CITY OF CONCORD

Concord Mills/Bruton Smith Blvd Mixed-Use Corridor Plan

Request for Qualifications #2564

ADDENDUM #1

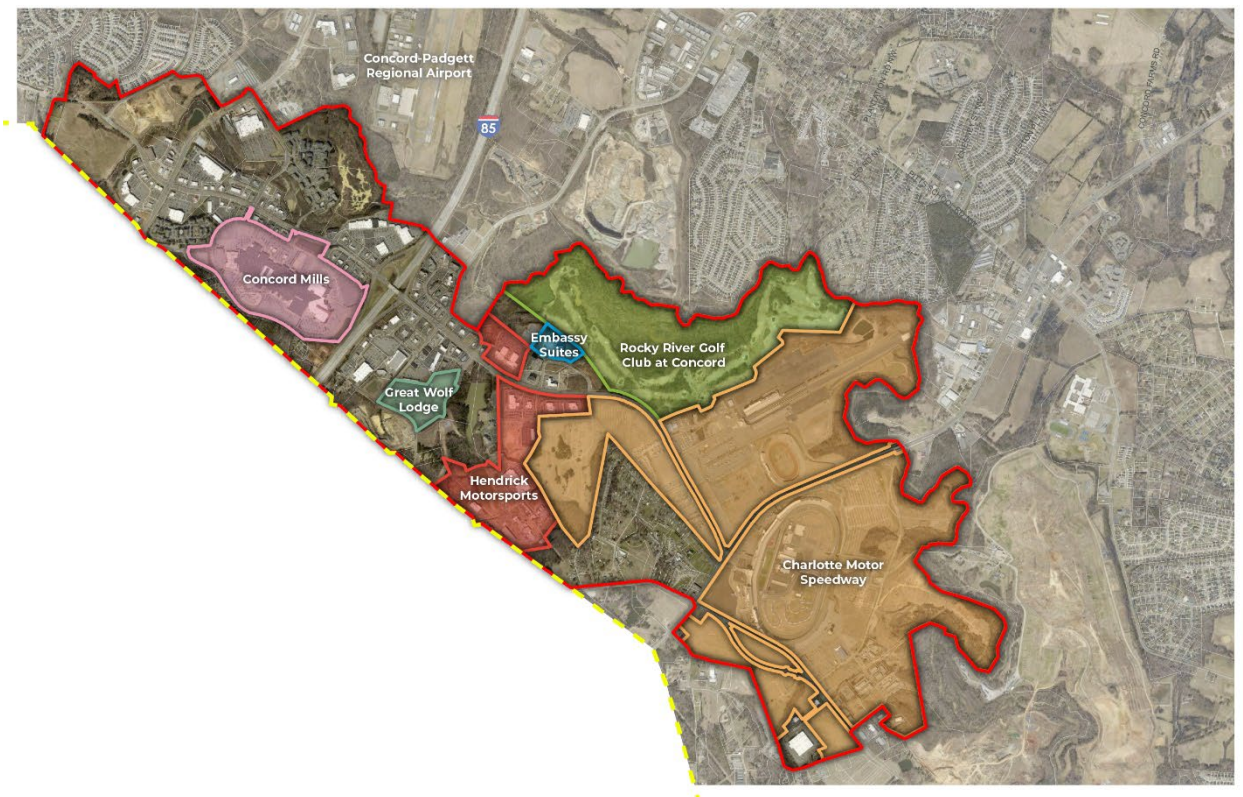
2. Regarding the diagram on page 5, is the project area 2,882 acres or is that including "beyond" the study are as well?

The 2,882 acres includes the entire area outlined in red. Please see the updated diagram below for further clarification.
